1995 - 1996 Corvette: Service Bulletin: Delayed Engagement (Replace Pump Cover Assembly)

Subject: Delayed Engagement (Replace Pump Cover Assembly)

Bulletin Number: 67-71-48

FIGURE 1. - HYDRA-MATIC 4L60-E TRANSMISSION IDENTIFICATION
INFORMATION

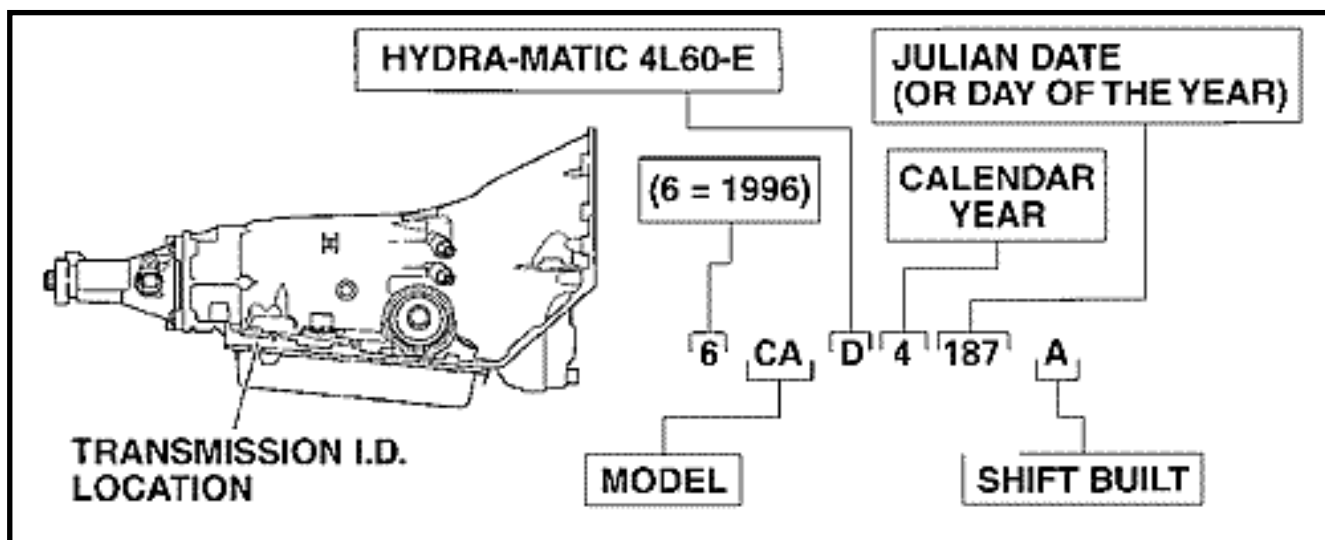
(FIGURES 1 AND 2) SOME OWNERS OF THE ABOVE MODELS, WITH A HYDRA-MATIC 4L60-E TRANSMISSION (BUILT BEFORE APRIL 29, 1996/JULIAN DATE 6120), MAY EXPERIENCE SOME DELAYED ENGAGEMENT WHEN VEHICLE IS NOT USED FOR MORE THAN 48 HOURS.

FIGURE 3. - TORQUE CONVERTER CLUTCH SIGNAL VALVE ASSEMBLY
LOCATION

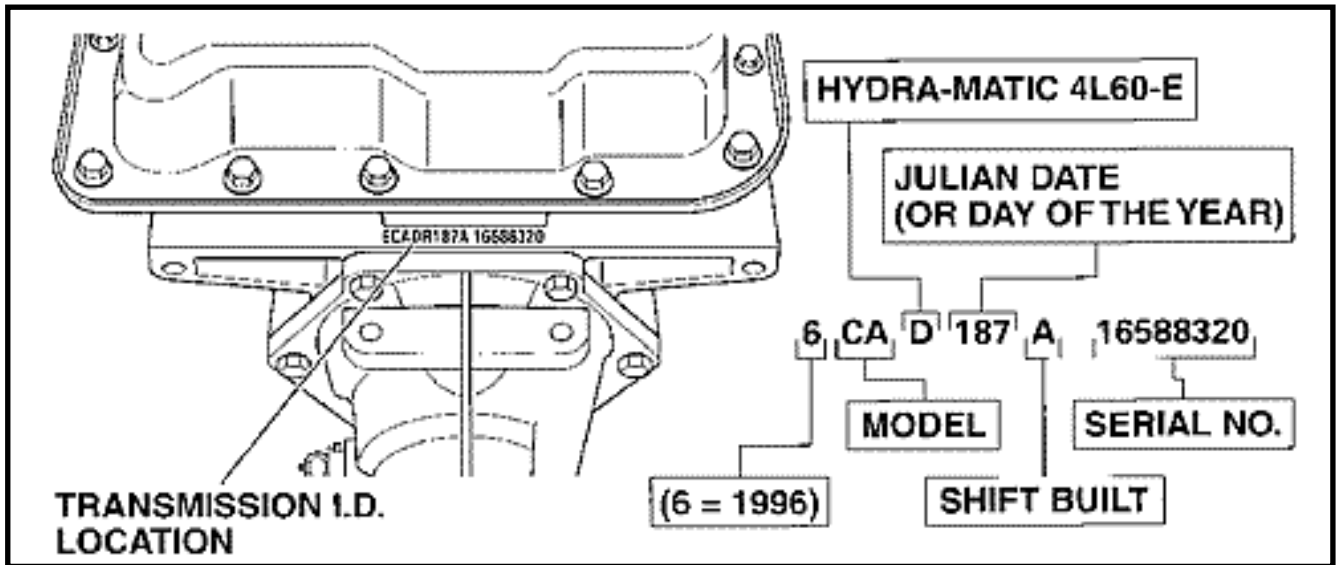
(FIGURE 3) REPLACE PUMP COVER ASSEMBLY WITH THE NEW TCC SIGNAL VALVE ASSEMBLY.
